UNITED STATES PATENT AND TRADEMARK OFFICE

APPLICATION NO.	FILING DATE	FIRST NAMED INVENTOR	ATTORNEY DOCKET NO.	CONFIRMATION NO.
10/556,005	11/08/2005	Atul Katoch	NL 030576	5020

Office Action Summary

DETAILED ACTION

Fig. Xa

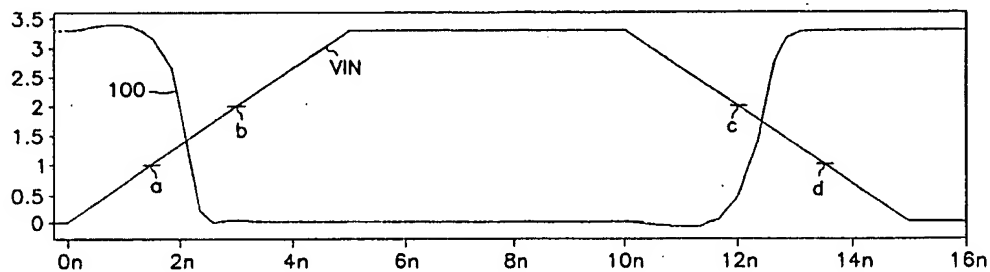
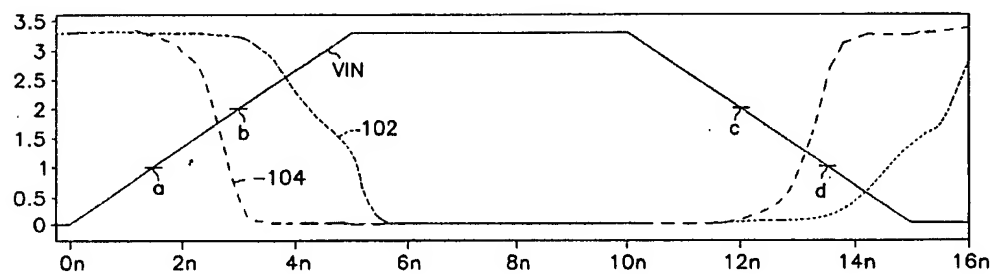
The drawings are objected to because Figure 7 is too condensed to see each specified signal at the times between 1-3ns and 5-6ns. The Examiner suggests either expanding Figure 7 (if possible) to provide one with the ability of differentiating the five

different signals or separating the signals on more than one stacked graph where signals can be view concurrently over the same time and voltage scale (the Examiner has provided and example of this for clarity).

Corrected drawing sheets in compliance with 37 CFR 1.121(d) are required in reply to the Office action to avoid abandonment of the application. Any amended replacement drawing sheet should include all of the figures appearing on the immediate prior version of the sheet, even if only one figure is being amended. The figure or figure number of an amended drawing should not be labeled as "amended." If a drawing figure is to be canceled, the appropriate figure must be removed from the replacement sheet, and where necessary, the remaining figures must be renumbered and appropriate changes made to the brief description of the several views of the drawings for
